Technical Solutions Report MCP 2

Miamisburg Closure Project

INDEPENDENT REVIEW OF THE  
MAIN HILL PROJECT ESTIMATES OF  
TRITIUM INVENTORIES, RELEASE FRACTIONS,  
AND OVERALL D&D APPROACH

**October 25, 2002**

**Figure 8.1 Tritium Inventory and Release Process**

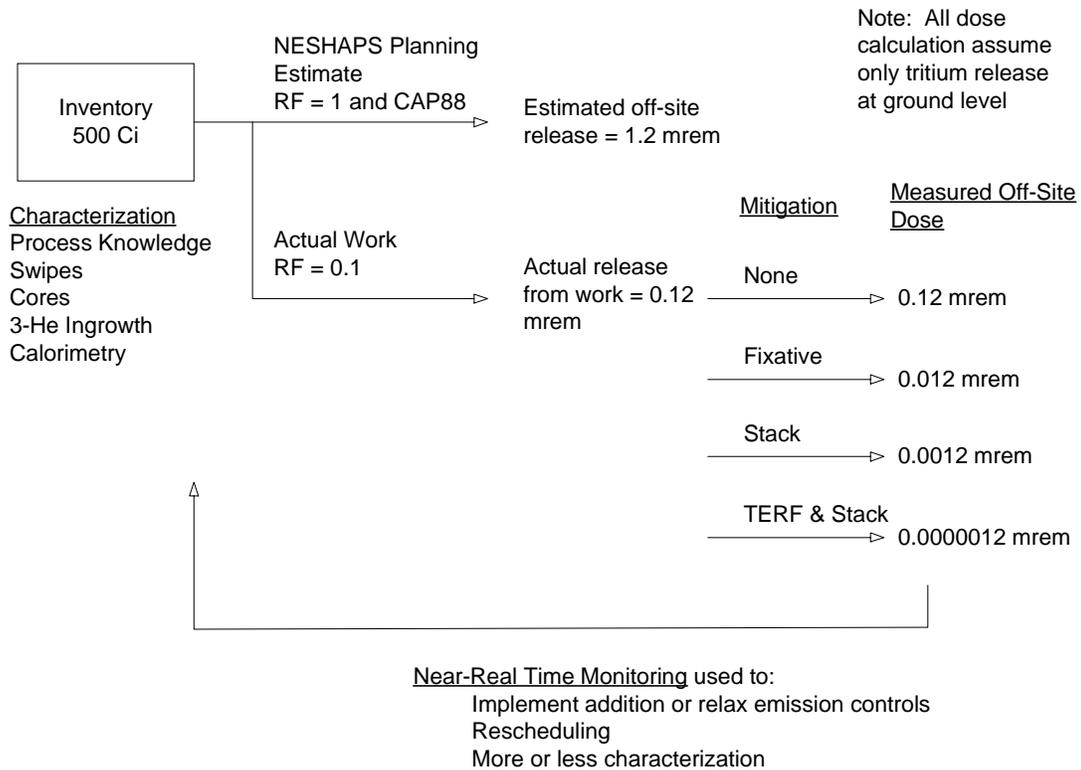
Figure 8.1 shows the varying dose risk associated with a 500 curie inventory based on the various release paths and mitigation features. This clearly shows that the dose can vary significantly with mitigative features; therefore, emphasis on dose is key.
